Columbia River System (CRS) Fish Facility Design Review Work Group (FFDRWG) USACE, Portland District (NWP) and Walla Walla District (NWW)

January 2026 Notes

Thursday, February 5th @ 09:00

- **Pictures from installation (Barnes)**

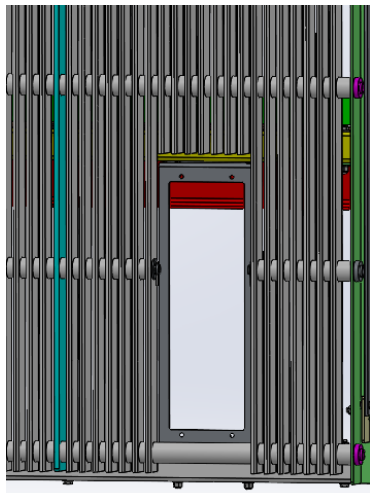
- *Opening for Fyke can be seen in red circle. There was a plate bolted on at fabrication that is spec-ed to be removed and finger trap added by Project. Opening is designed for off-the-shelf products from Neptune Marine Products. Model RF 105 – 7” x 23.25” Trigger Model. Fyke will be purchased prior to summer and installed in opening seen in picture below.*
